January 17, 2002

Subject: Revision 1 to Byron Station, Unit 1 Cycle 11A, Core Operating Limits Report and
Revision 1 to Byron Station, Unit 2 Cycle 10A, Core Operating Limits Report

**Byron Station Unit 1 Cycle 11A Core Operating Limits Report
Revision 1**

Byron Station Unit 2 Cycle 10A Core Operating Limits Report Revision 1

Figure 2.8.1 Axial Flux Difference Limits as a Function of Rated Thermal Power

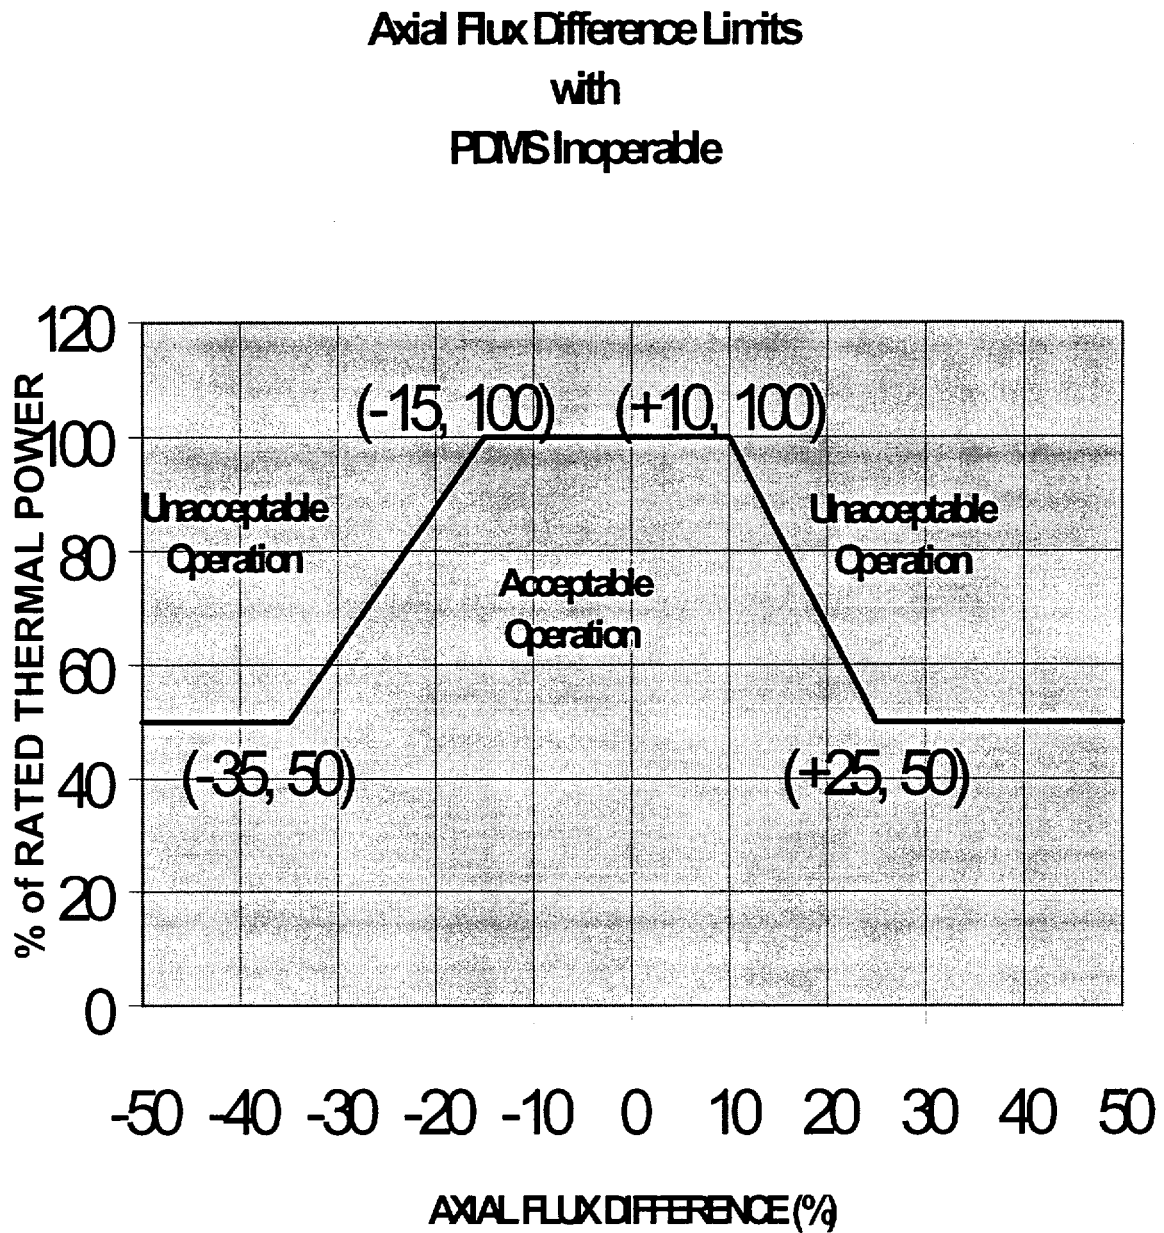
In accordance with Technical Specification 5.6.5, "Core Operating Limits Report (COLR)," we are submitting the revised COLRs for Byron Station, Unit 1 Cycle 11A, and Byron Station, Unit 2 Cycle 10A. The Unit 1 and Unit 2 COLRs were revised to add an End of Life, All Rods Out, Hot Full Power Moderator Temperature Coefficient limit at 60 parts per million Reactor Coolant boron concentration and to consolidate the shutdown margin limits for the various modes. In addition for Unit 2, the Hot Full Power, Axial Flux Difference upper limit was revised from +5% to +10% with the Power Distribution Monitoring System inoperable.

2.8.1 When PDMS is Inoperable, the AXIAL FLUX DIFFERENCE (AFD) Acceptable Operation Limits are provided in Figure 2.8.1 or the latest valid PDMS Surveillance Report, whichever is more conservative.

Figure 2.8.1 Axial Flux Difference Limits as a Function of Rated Thermal Power

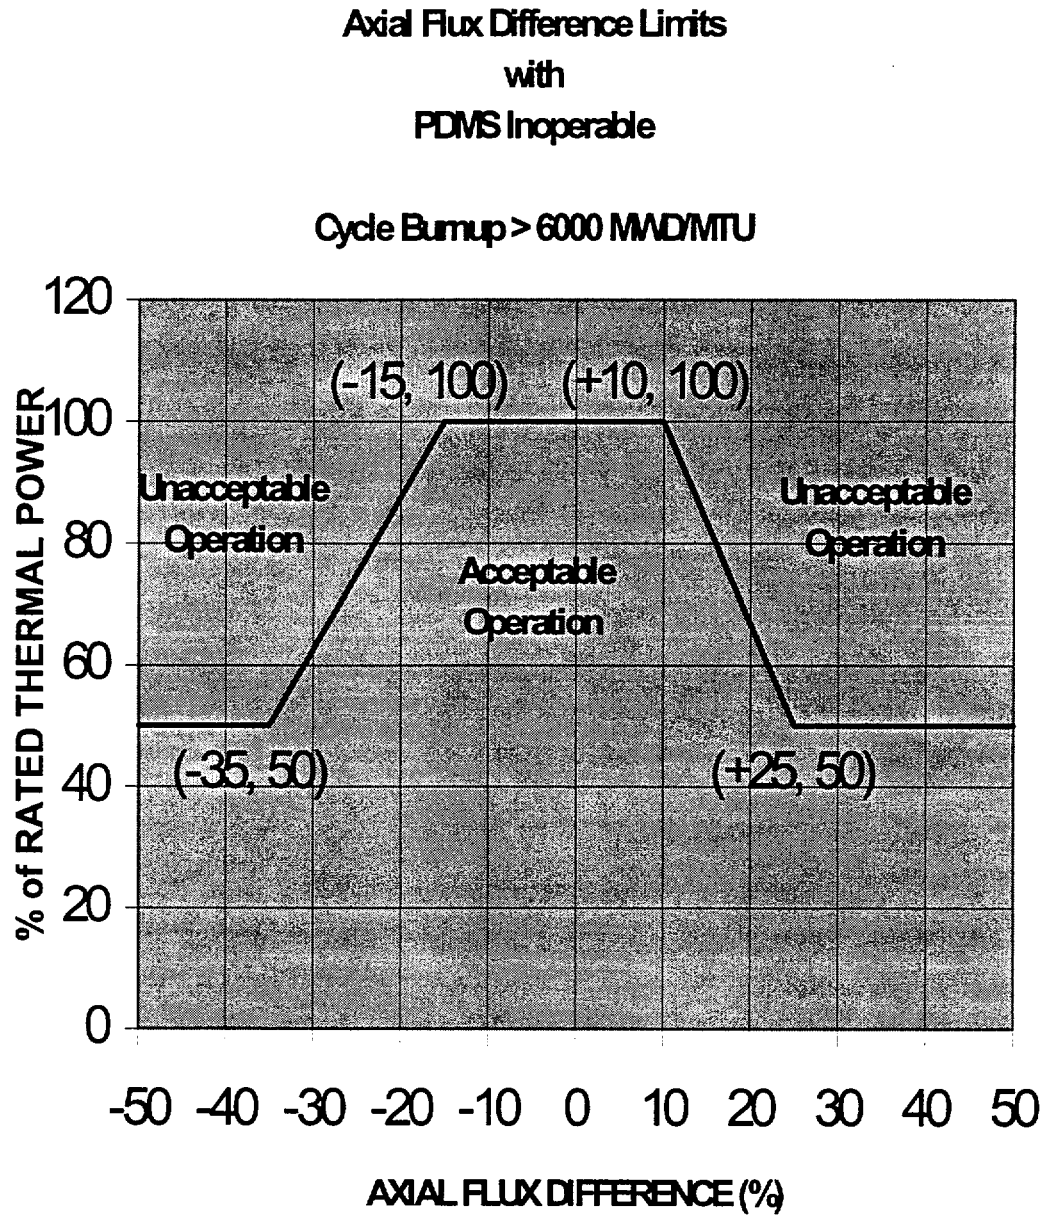
In Revision 1, the SDM limits for MODE 5 were revised to 1.3% $\Delta k/k$ for LCO 3.1.1. Revision 1 also incorporates the EOL HFP ARO MTC surveillance limit at 60 ppm. Finally Revision 1 revises the AFD band to +10 at HFP conditions (Figure 2.8.1). Byron Station is requested to perform a Plant Review of this document. Upon completion of the Plant Review, Byron Station is to transmit the COLR portion to the Nuclear Regulatory Commission pursuant to Technical Specification 5.6.5. Please provide NFM (Brian Manges) with a copy of Byron Station's completed Plant Review and COLR submittal to the NRC. This TODI supercedes Reference 7.

2.8.1 When PDMS is Inoperable, the AXIAL FLUX DIFFERENCE (AFD) Acceptable Operation Limits are provided in Figure 2.8.1 or the latest valid PDMS Surveillance Report, whichever is more conservative.
